SUBJECT: Supplement B to the Application for Certification
Hidden Hills SEGS (11-AFC-2)

Response to Data Adequacy Review

**Hidden Hills Solar Electric
Generating System
(HHSEGS)**

(11-AFC-02)

Attachment B2
Wetland Delineation Figures

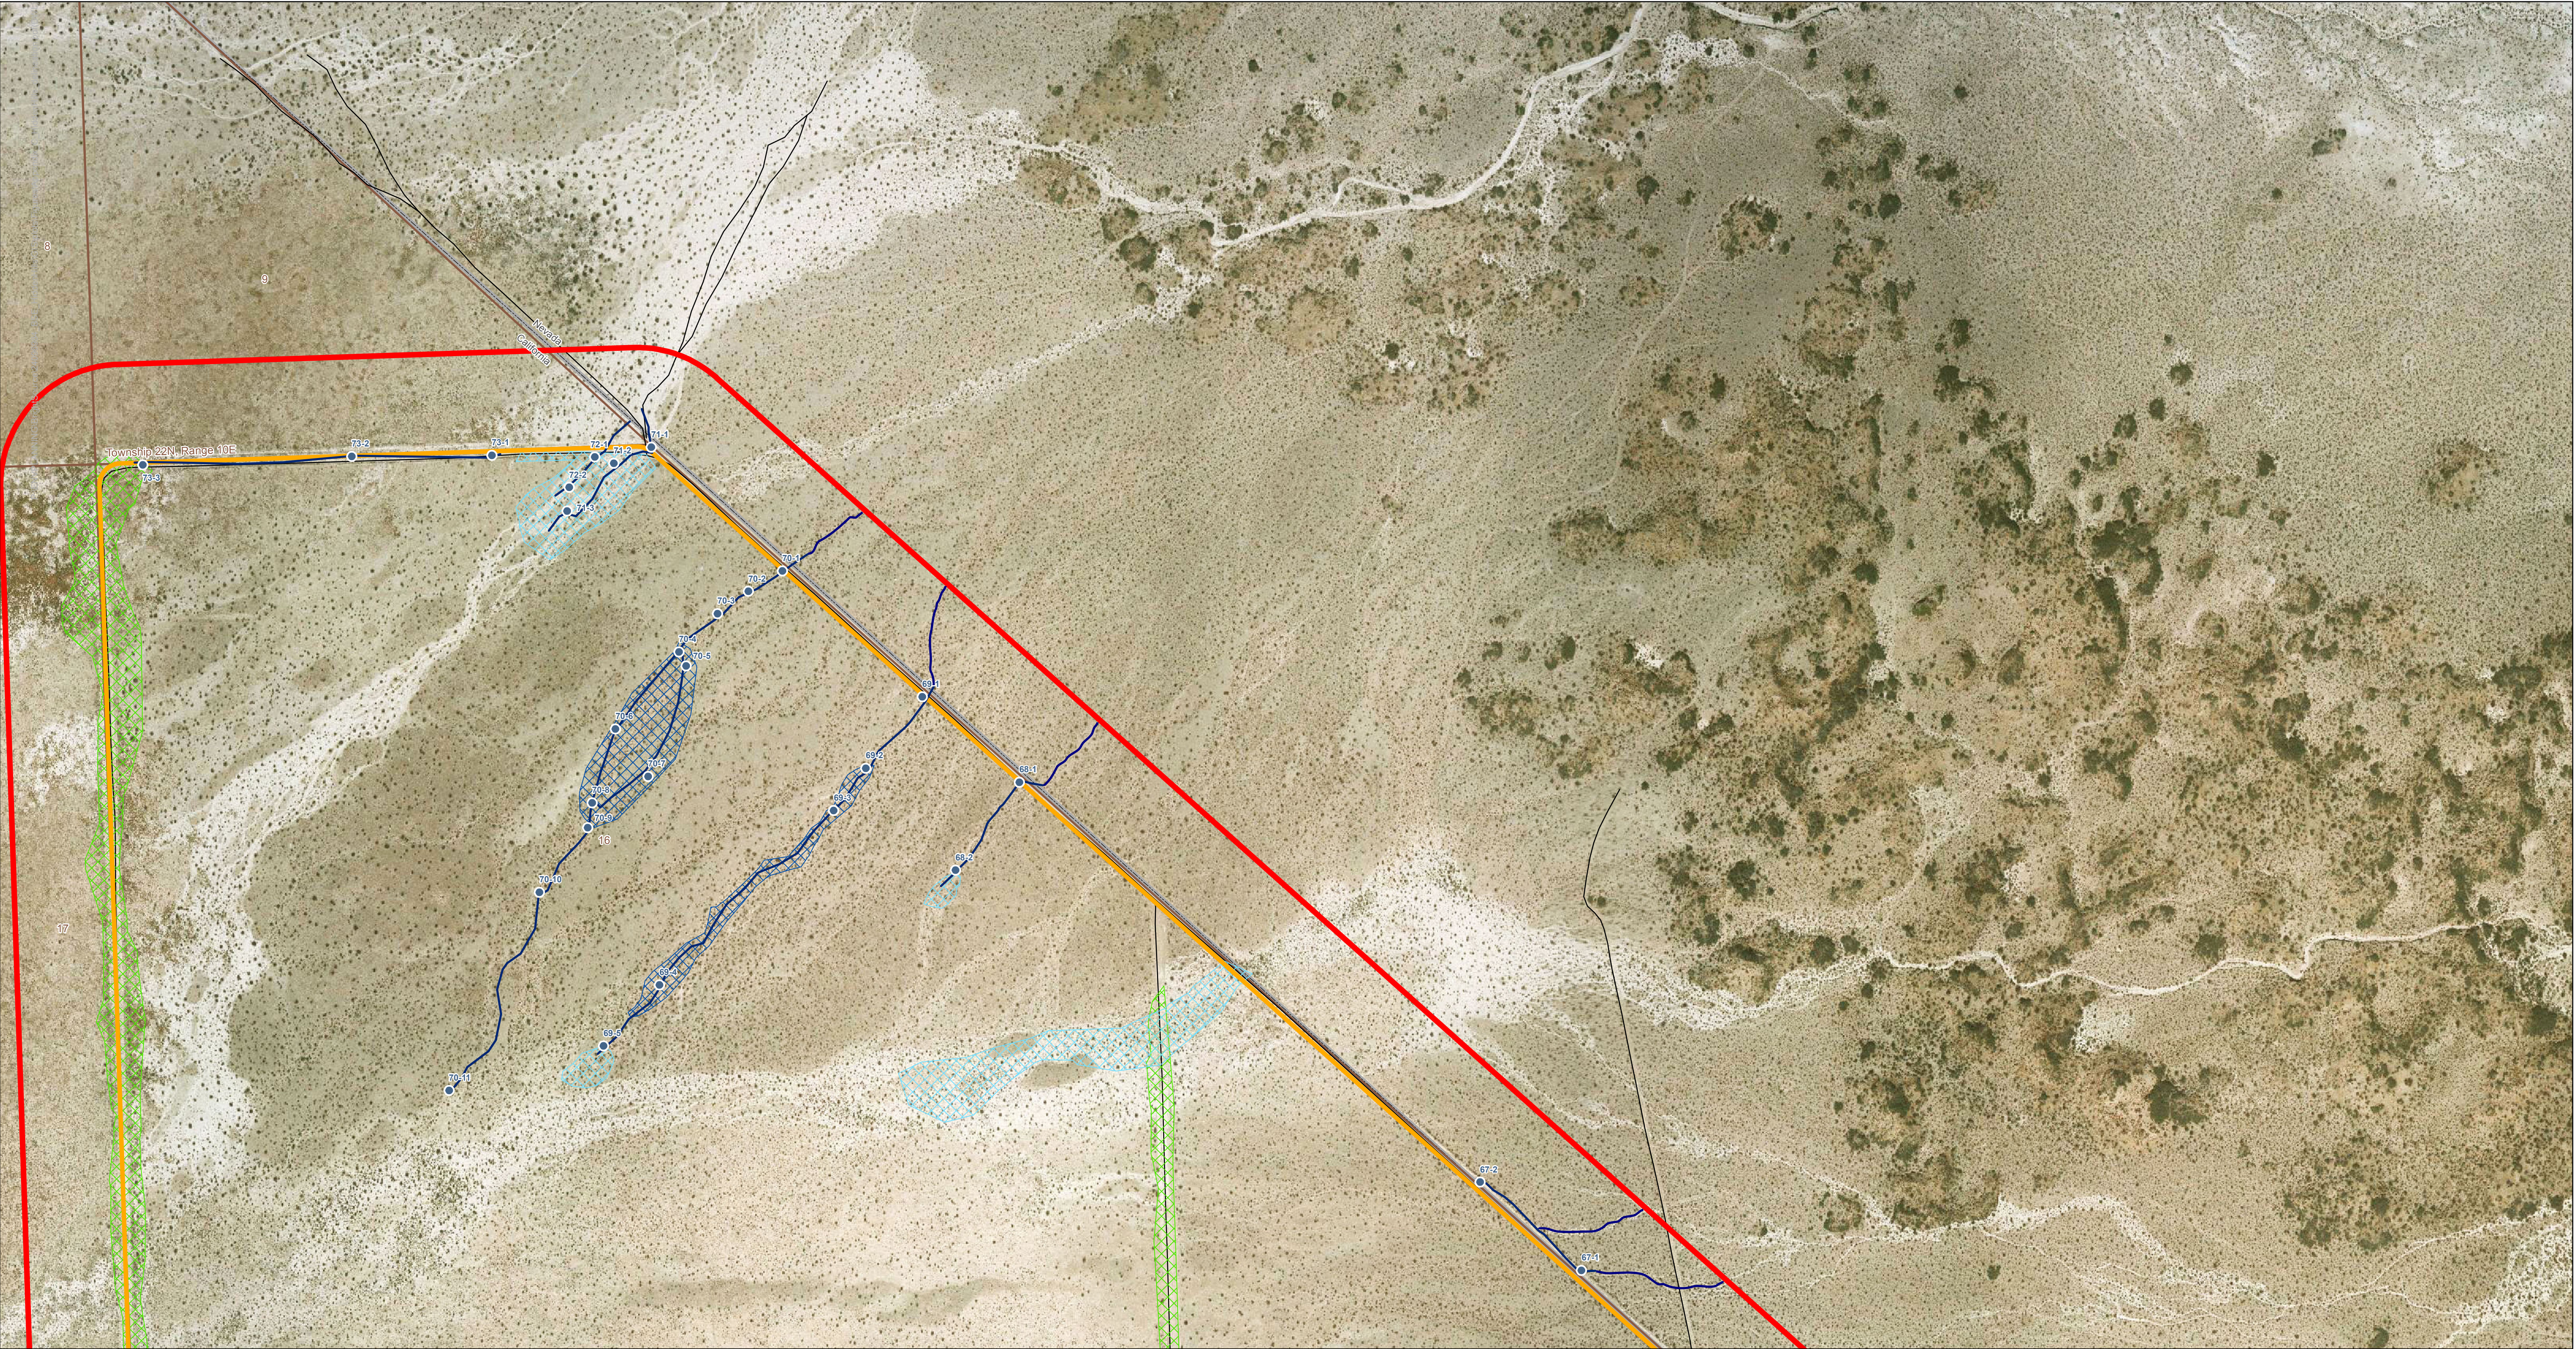
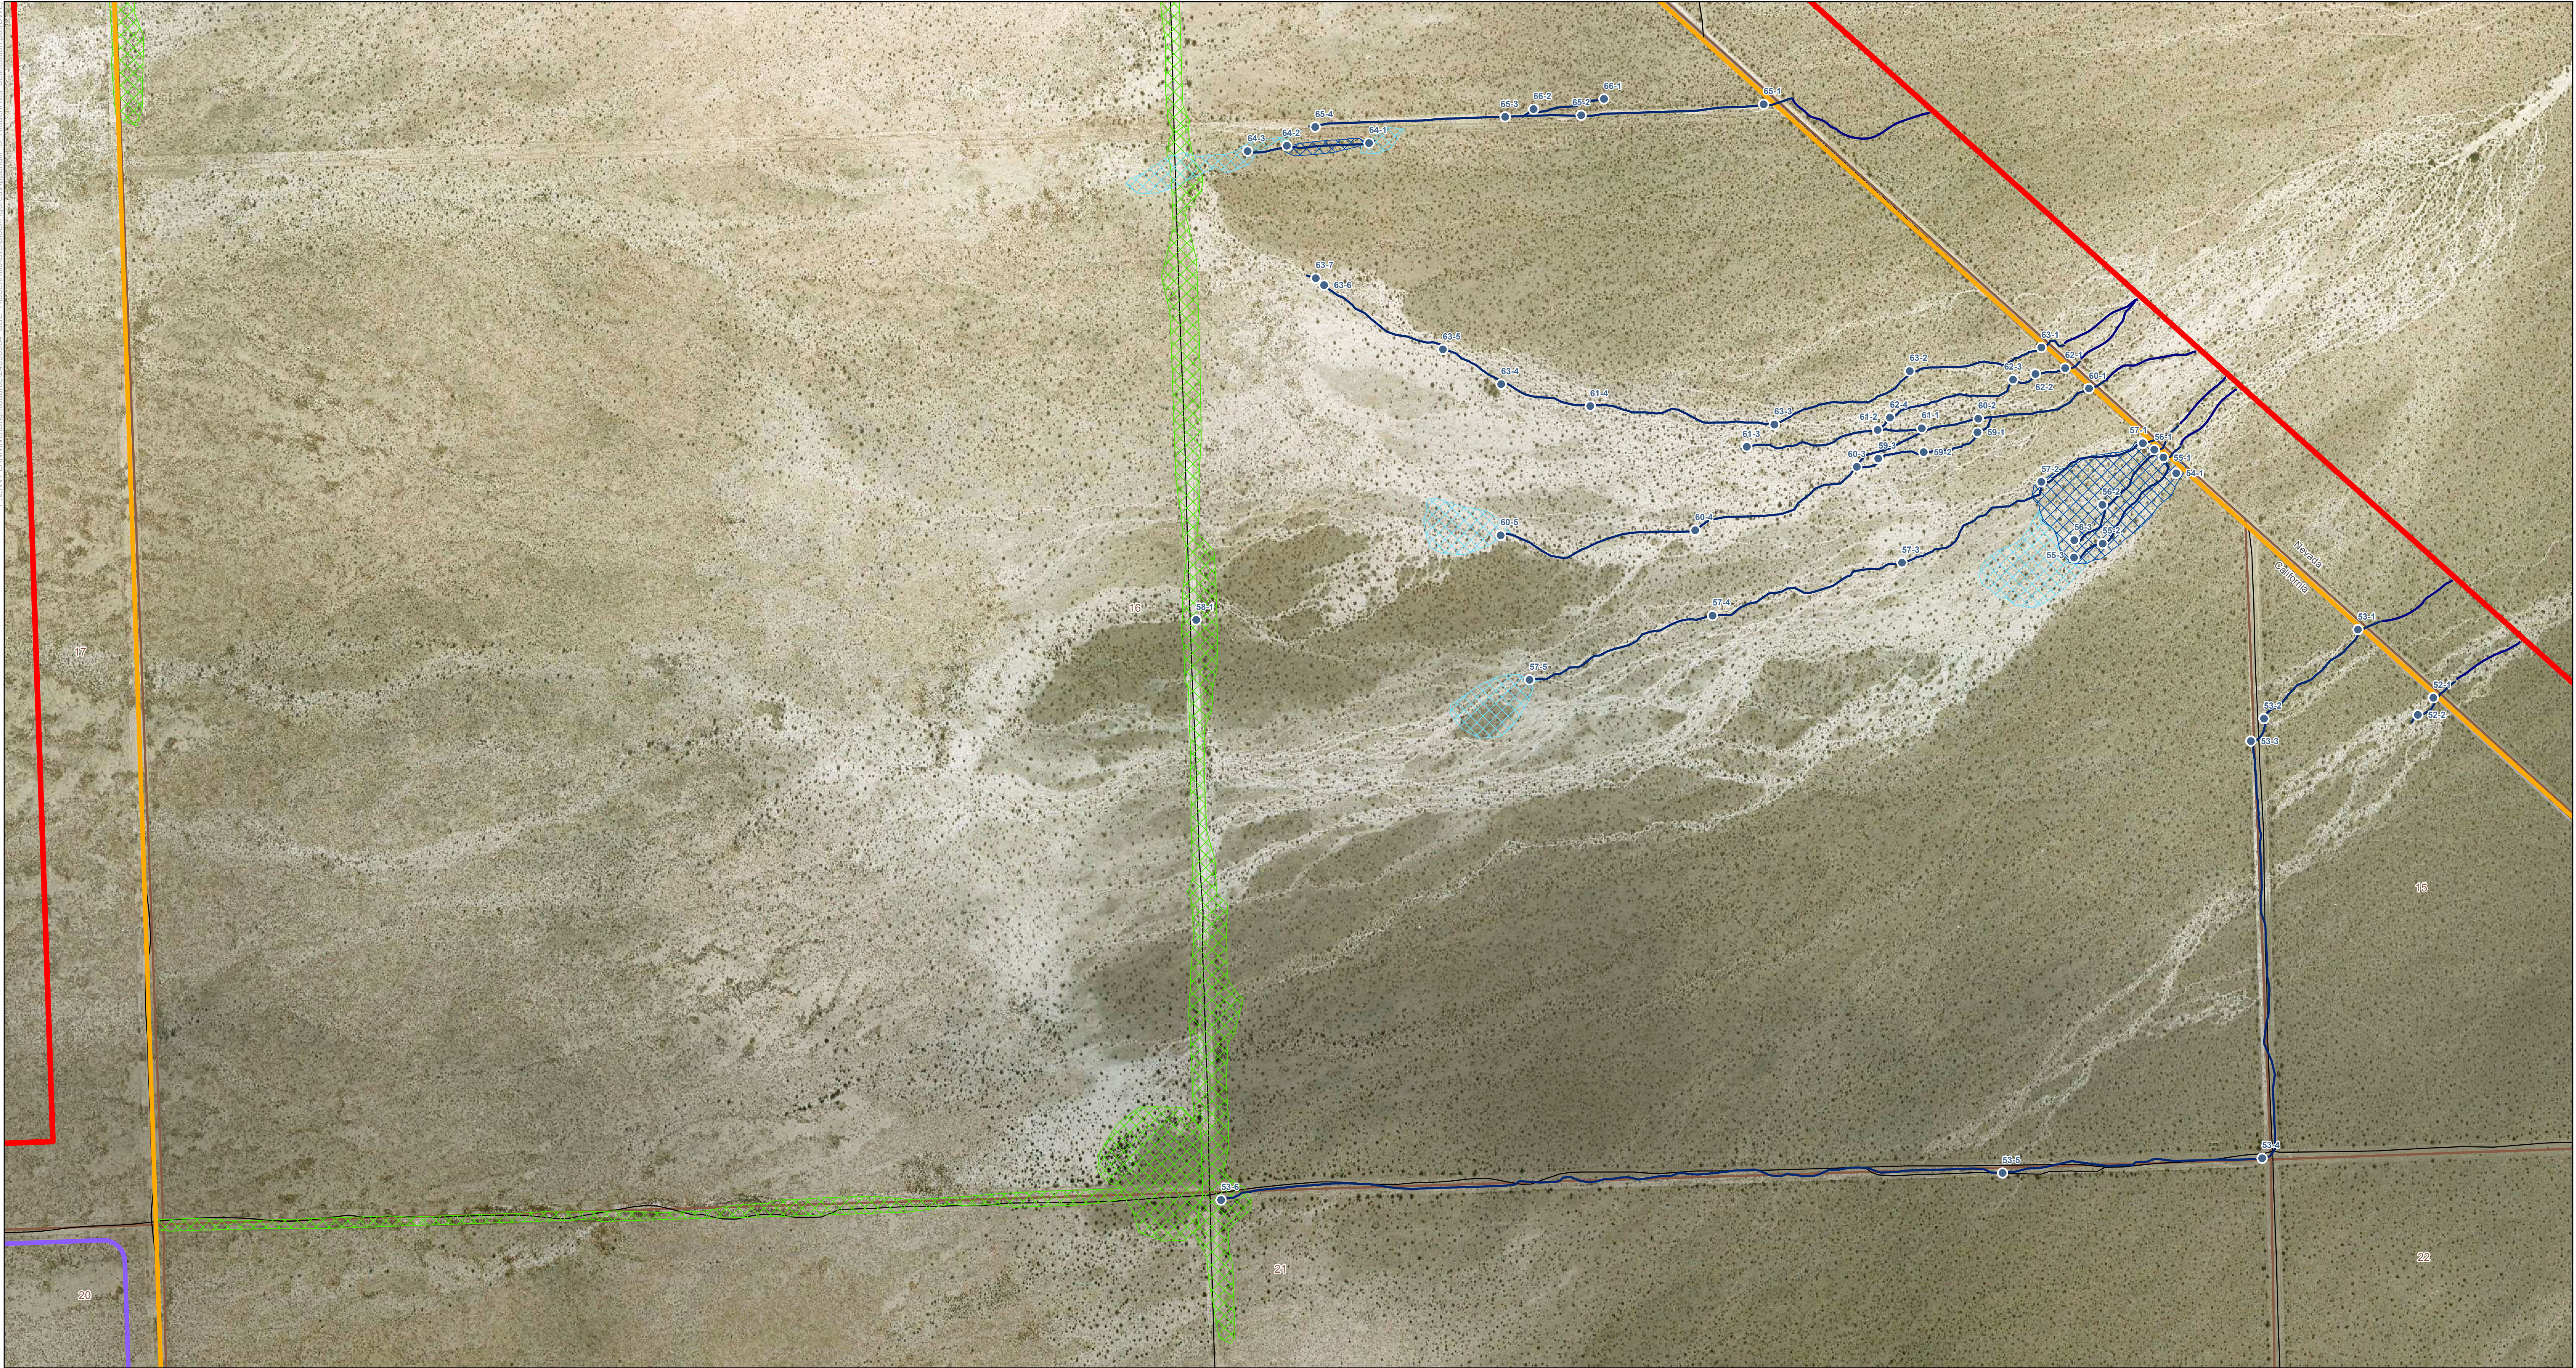
Please provide maps a scale of 1:2,400 showing any potential jurisdictional and non-jurisdictional wetlands delineated out to 250 feet from the edge of disturbance if wetlands occur within 250 feet of the project site and/or related facilities that would be included with the US Army Corps of Engineers (USACE) Section 404 Permit application. Provide an aerial photos or wetland delineation maps of jurisdictional and nonjurisdictional waters of the U.S. that occur beyond the project site to conform to the delineation out to the 250 foot buffer beyond the project boundary.

Response- Although these maps were provided in the initial September 2011 Data Adequacy submittal, there was a printing error and the delineation information for the 250-foot buffer was not clearly displayed. Five new sets of the drawings have been reprinted and the corrected maps are being provided to CEC staff as Attachment B2. Electronic copies will be provided to others upon request. The wetland delineation of
